STAFF REPORT 04-13-2022 MEETING
APPLICATION NUMBER: 21-7735
ADDRESS: 1416-1444 MICHIGAN AVENUE
HISTORIC DISTRICT: CORKTOWN
APPLICANT/ARCHITECT: TIM FLINTOFF/4545ARCHITECTURE
OWNER OF RECORD: ANTHONY O'DONNELL (1444), 1400 MICHIGAN LLC (1416)
DATE OF STAFF SITE VISIT: 04-01-2022

SCOPE: ERECT ROOF/SIDE ADDITIONS, OTHER EXTERIOR ALTERATIONS

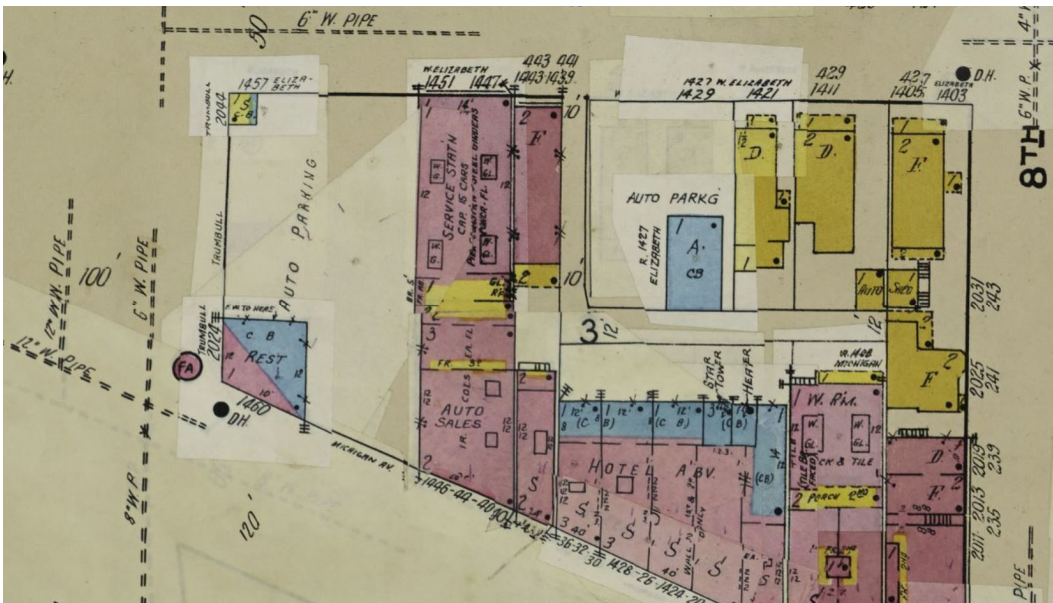
- The first question for staff and the Commission is whether the 3-story section's roofline at the rear of the historic building constitutes a "distinctive character-defining feature" meriting preservation. Such features should generally be related to the architecture or historical significance of the building, in its role as a contributing structure to the overall district. Staff recommends that the existing 3-story expression at the rear, a background element and apparently unrelated to any important and significant historic function, is not a distinctive feature of this building. This opens up the possibility that this section may be appropriately altered without violating the Standards.

Rendering of proposed rooftop addition, from applicant's submission. Birds eye view towards the northeast. Red arrows, added by staff, denote proposed additional building massing. Purple line represents approximates district boundary.

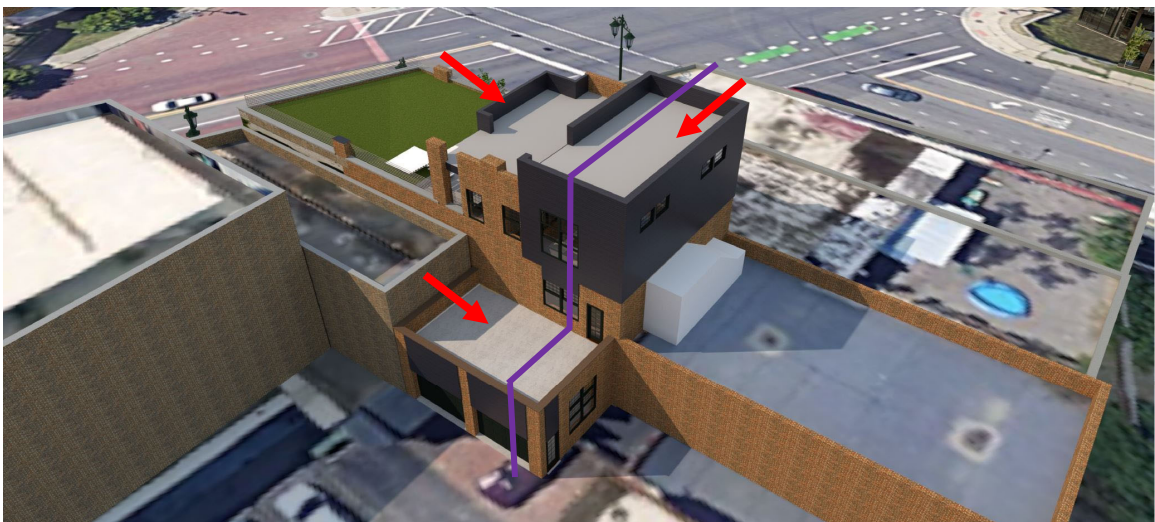
- The second question regarding the rooftop work is the character of the addition itself. Staff notes that the proposed cladding material of Hardie siding is a modern analog of traditional construction materials, and is used in a way that does not necessarily detract from the building. However, it should be noted that a lapped siding system is somewhat out of place on an addition to a large "Main Street"-type brick commercial building, though perhaps not demonstrably "inappropriate," in staff's opinion. A metal panel, cementitious panel, or other commercial-grade cladding system, as opposed to lap siding more familiar for its residential applications, may be a better choice.

- The doors opening out on to the proposed roof deck and the circulating exterior stair, are all compatible elements of a modern addition. The glass railing, especially its prominence at the Michigan Avenue façade, is less compatible with the historic commercial vocabulary of the resource. As opposed to the rest of the design, the railing appears to be much more of a crowning element for the historic building than an associative element of the addition. An painted steel railing system would be more appropriate

- The majority of the proposed roof addition work is set back from the Michigan Avenue elevation. However, the glass/aluminum railing surrounding the large roof deck is proposed to be hard against the Michigan Avenue parapet, potentially becoming a prominent element along this historic streetwall. The potentially jarring effect of this glass panel railing is exacerbated by the missing historic cornice on this building. Staff recommends that (1) either a cornice of appropriate design be added back to the building to de-emphasize the “crowning effect” of the new glass railing, or that (2) the modern glass railing recess at least 5’ from the primary elevation, to limit its visibility from Michigan Avenue, or that (3) the railing be replaced by a dark-painted steel railing system.

- The roof deck glass railing system proposed along the primary Michigan Avenue facade be recessed a minimum of 5’ from the outer edge of the parapet

- A cornice of compatible design, as approved by staff, be restored to the building to reassert the historic Michigan Avenue façade and de-emphasize the prominence of the proposed roof railing (and/or the entire roof deck railing, including the sides, be revised to be a dark-painted steel guardrail system that is less obtrusive, approvable per staff review).

Rendering of proposed garage/addition, birds eye view towards southwest, from applicant's submission. Red arrows, added by staff, denote the new building massing. Purple line represents approximates district boundary.

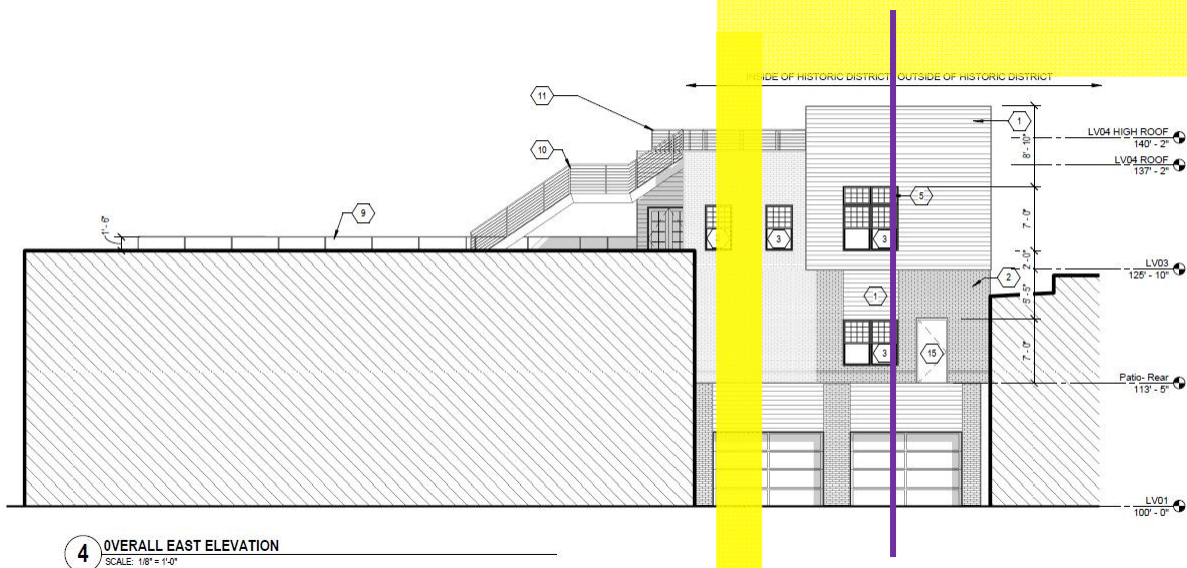
- The proposal features materials and design vocabulary that complements the context, and is clearly differentiated from the historic portions. As the existing commercial building is already large, it does not overwhelm it.
- The proposed garage/workshop addition is much less visible and incorporated into the “back of house” area adjacent to the current parking lot. Its detailing and design are compatible.
- Staff finds that the proposed addition, while large, nevertheless meets the Standards and Guidelines relevant to additions, in that it is sensitively designed to be true to its own era while preserving the massing, expression, and distinctive historic materiality of the Michigan Avenue facade.
